REVIEW COMMENTS / INLINE MARKUPS

SP ENGINEERING (MAIN CONTRACTOR)		
CoolAir HVAC Systems (Subcontractor)		
PROJECT: SPCL		
TITLE		
Chilled Water Piping Layout ? Tower B, Levels 12?18		
DOCUMENT NO.	REV	SCALE
SPCL-MEP-DWG-0452-C	C	NTS
TYPE	DATE	
Drawing / MEP	2026-07-06	
STATUS		
[PENDING REVIEW]		
FILE: SPCL-MEP-DWG-0452-C.pdf

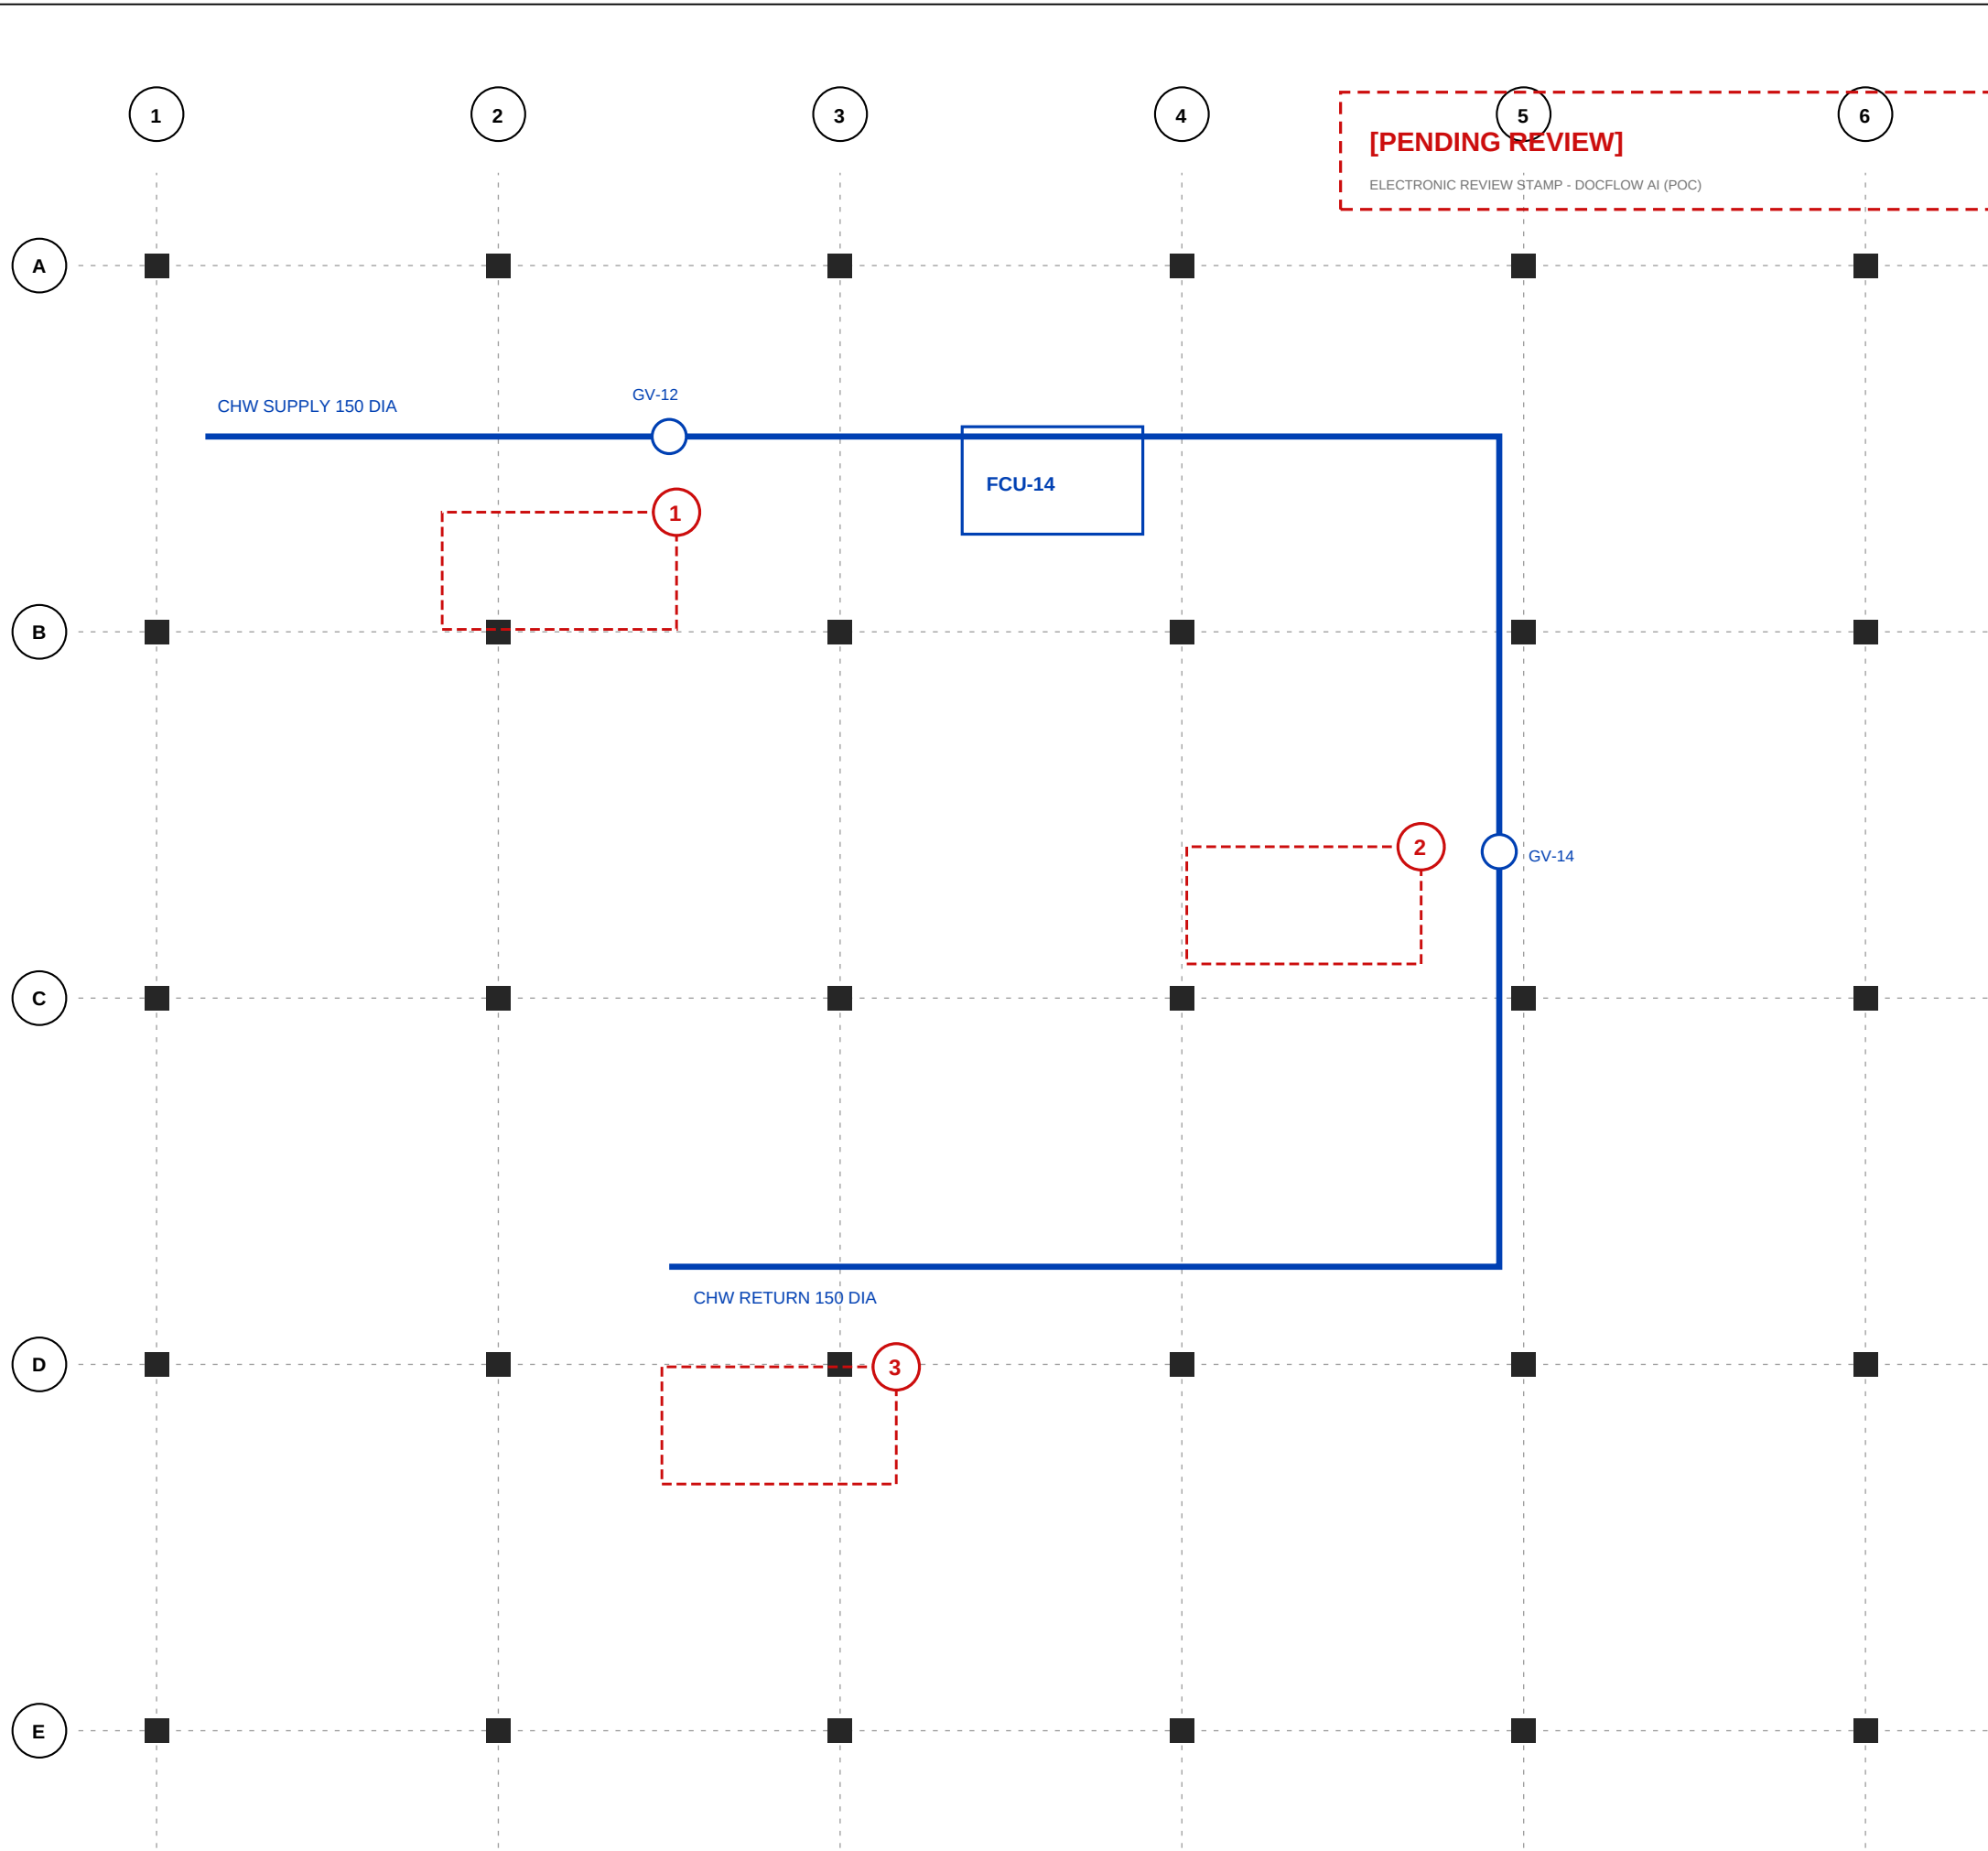
Rajesh Iyer (Reviewer/Approver)
2026-07-09 16:40
Riser shaft clash at L14 flagged in Rev B appears resolved. Verifying insulation spec against MEP-SPC-0031 before sign-off.
- 3

Suresh Patel (Contractor/Subcontractor)
2026-07-10 09:05
Insulation updated to 32mm nitrile as per Code 2 comment on Rev B. See sheet 7 note 4.
